PRODUCT / PROCESS CHANGE NOTIFICATION

1.1 Company		STMicroelectronics International N.V
1.2 PCN No.		ADG/18/10614
1.3 Title of PCN		SO-20 Products (U726,UH01,UH21,UH44,UR35): Migration to SO20 IDF (Inter Digit Frame) line with new BOM and matte Tin plating process
1.4 Product Category		see list
1.5 Issue date		2018-01-29

SO-20 Products (U726,UH01,UH21,UH44,UR35): Migration to SO20 IDF (Inter Digit Frame) line with new BOM and matte Tin plating process

Change description

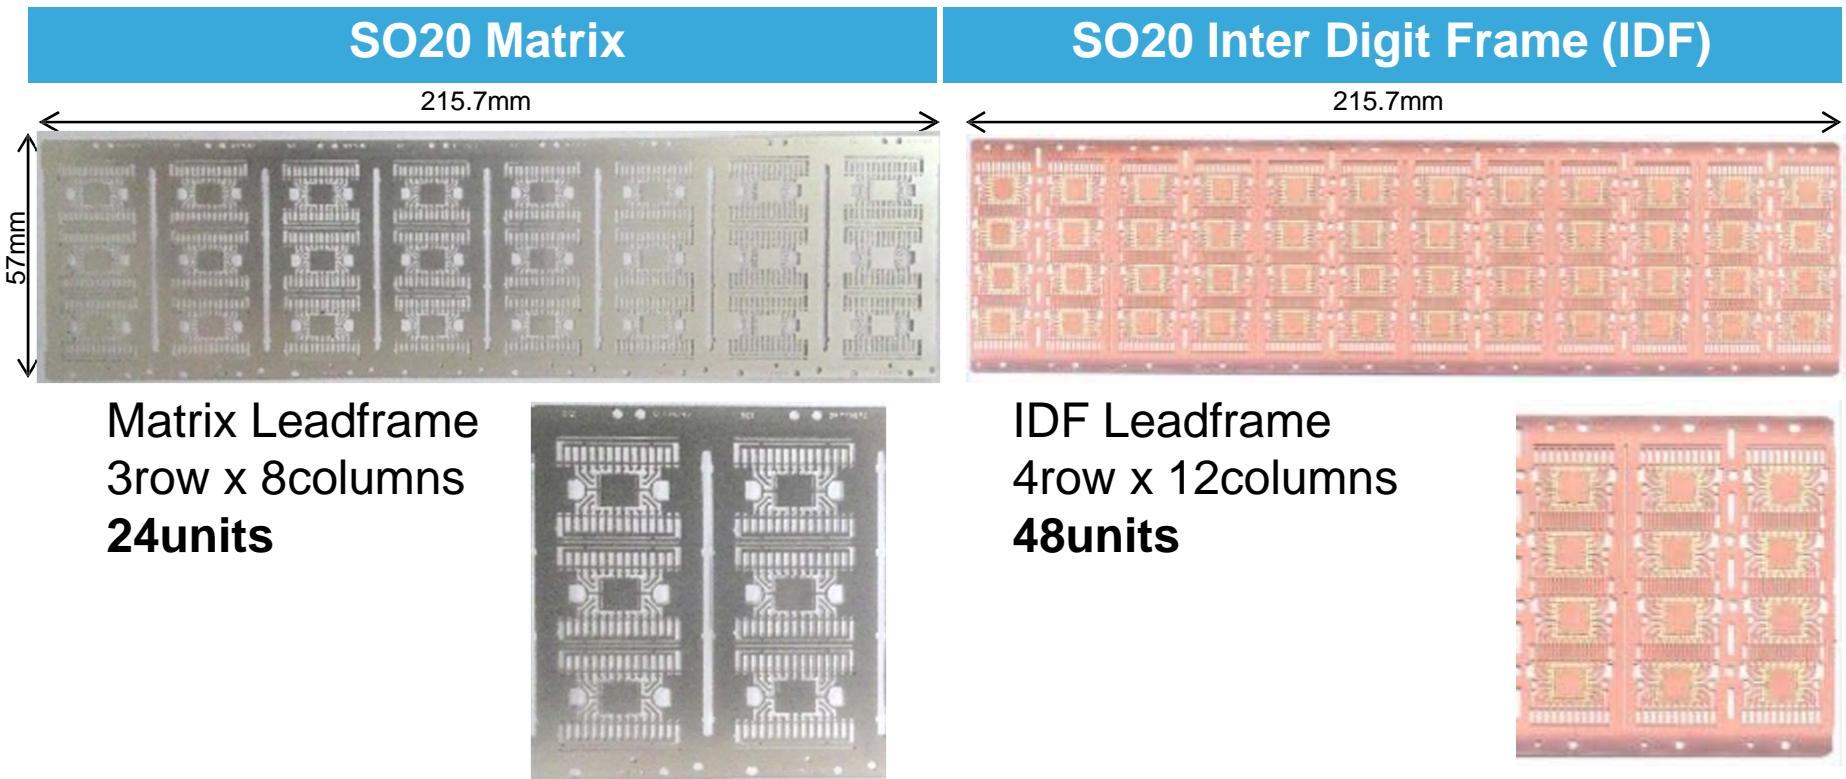
Migration from SO20 Matrix to High Density Line IDF (Inter Digit Frame)

New Bill of Material (BOM)

- Copper frame (SpAg/RgAg/SelAg) with ME2 treatment for rough surface
- Copper wire bonding
- Resin Sumitomo EME-G633CA
- Glue Loctite Ablestik ABP8302

Matte Tin plating process introduction

Existing frame vs ME2

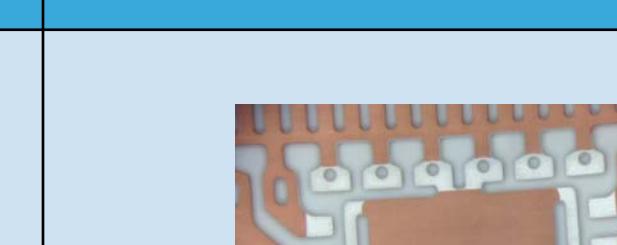
Adv.Micro PPF	IDF + Cu pad (with ME2)
